TO: City Council
FROM: Ken Roberts, Planning Director
AGENDA ITEM: **Four Corners 2nd Addition** – Preliminary Plat, Preliminary Planned Unit Development (PUD) Plans, Zoning Map Amendment and Right-of-Way Vacations
REVIEWED BY: Jack Griffin, City Engineer
Ben Prchal, City Planner

To: Ken Roberts, Planner Director	Re: Four Corners 2nd Addition
Cc: Chad Isakson, Assistant City Engineer	Preliminary Plan Engineering Review
From: Jack Griffin, P.E., City Engineer

An engineering review has been completed for the Four Corners 2nd Addition Preliminary Plat/Plans received on January 31, 2019. The submittal consisted of the following documentation:

FOUR CORNERS 2ND ADDITION PRELIMINARY PLAT

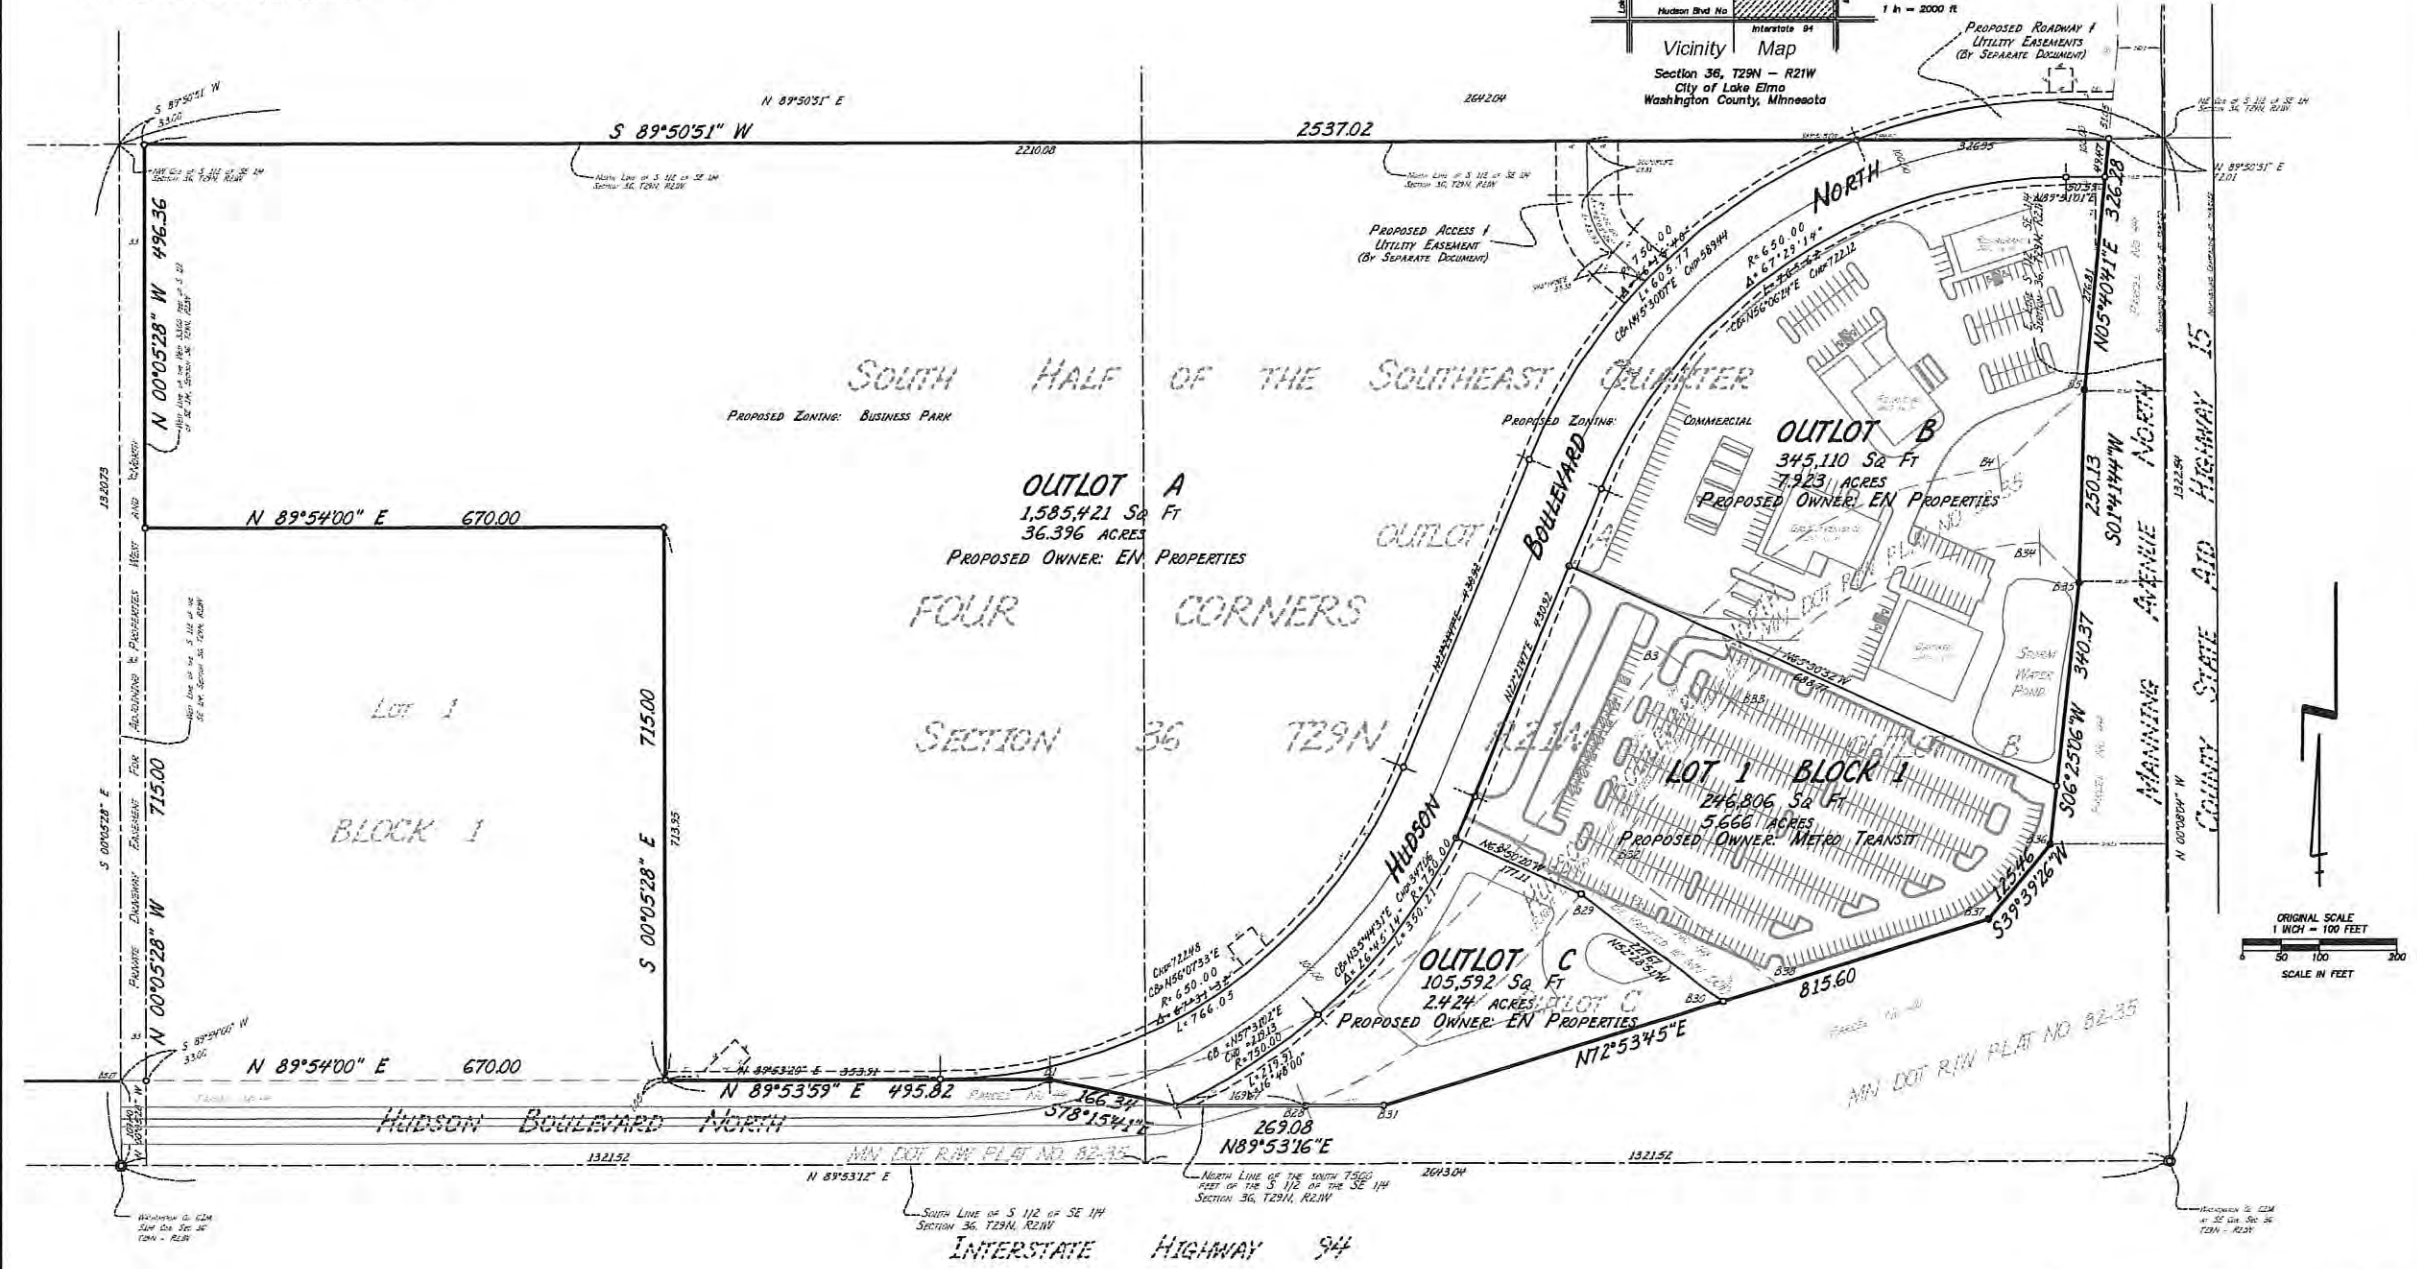
- Outlots A, B, and C are proposed to be owned by EN Properties. Outlots have been labeled on some plans but must also be identified on the street, utility and grading plans.

- A drainage and utility easement must be provided over all of Outlot C. The Outlot C drainage easement will allow for City maintenance of the storm water BMPS and storm sewer system. The drainage and utility easement must be shown on the Preliminary Plat and Preliminary Plans.

- Additional drainage and utility easements must be identified and shown on the Preliminary Plat and Construction Plans (street, utility and grading plans).

- Add drainage and utility easements for the drainage ditch on the north side of Hudson Boulevard.
 - Add drainage and utility easements for the street culvert 100-year HWL.

FOUR CORNERS 2ND ADDITION
PRELIMINARY PLAT
Existing Tree Inventory

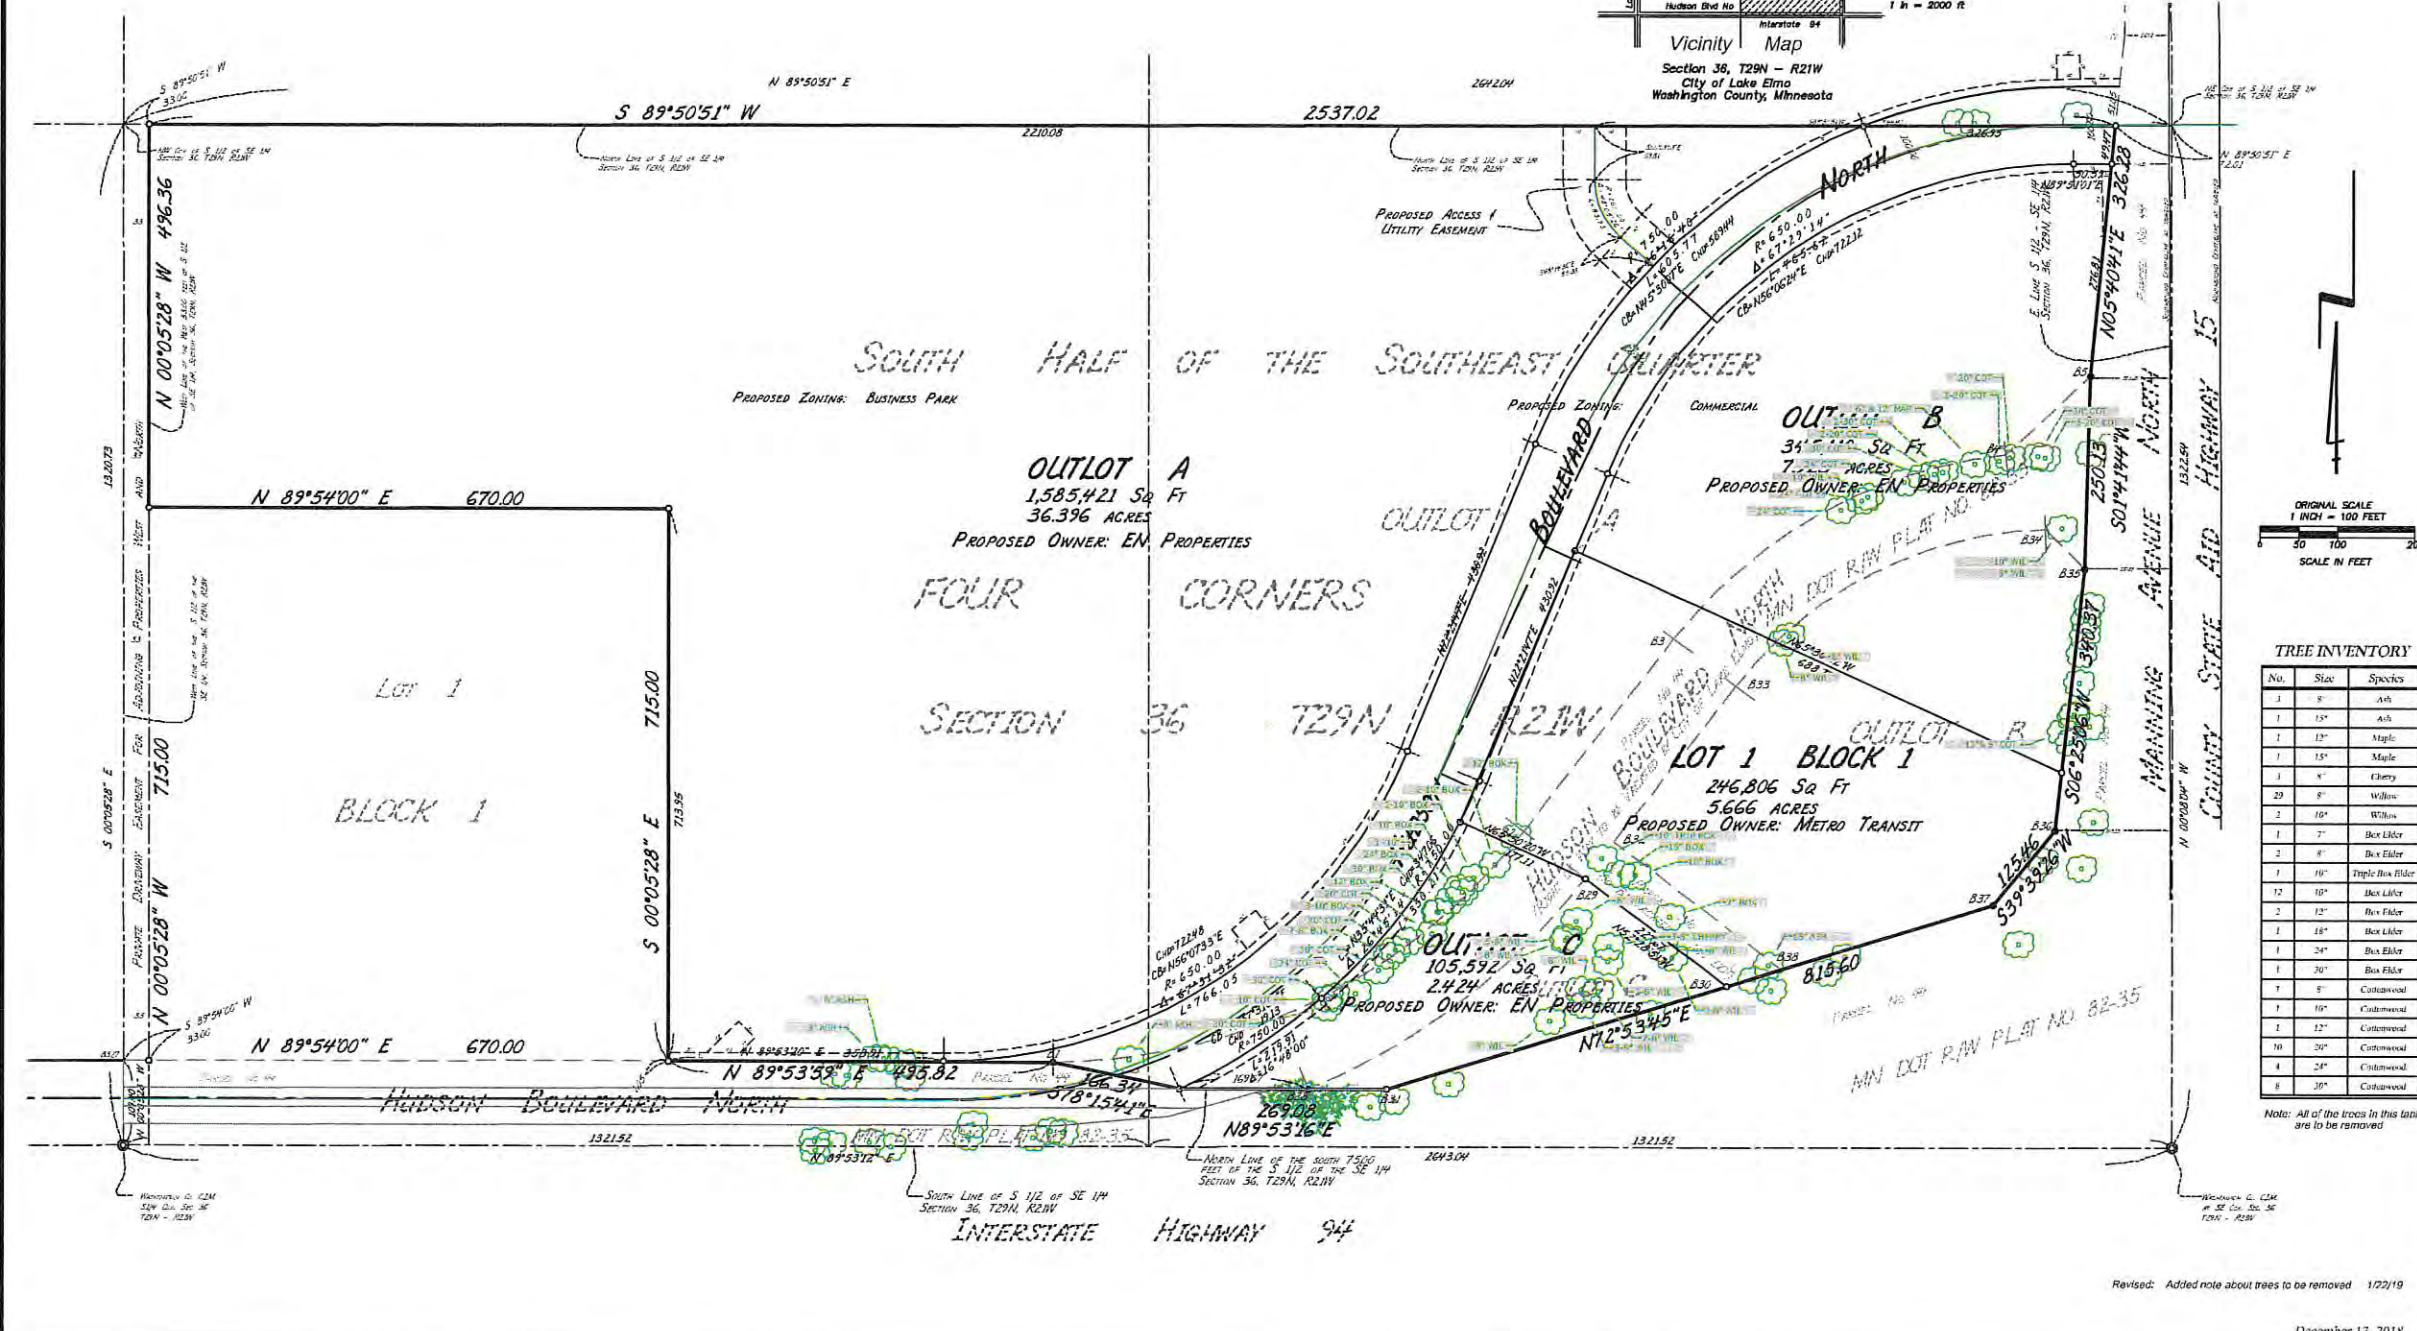
Tree Preservation. The project surveyor identified 86 total trees within the project site. Most of the existing trees are along the existing Hudson Boulevard and in the area of the proposed storm water pond. They are primarily willow, box elder and cottonwood trees with 4 ash, 2 maple and 3 cherry trees. The developer will need to remove all the trees within this project area to construct the new road and to build the proposed storm water pond on Outlot C.
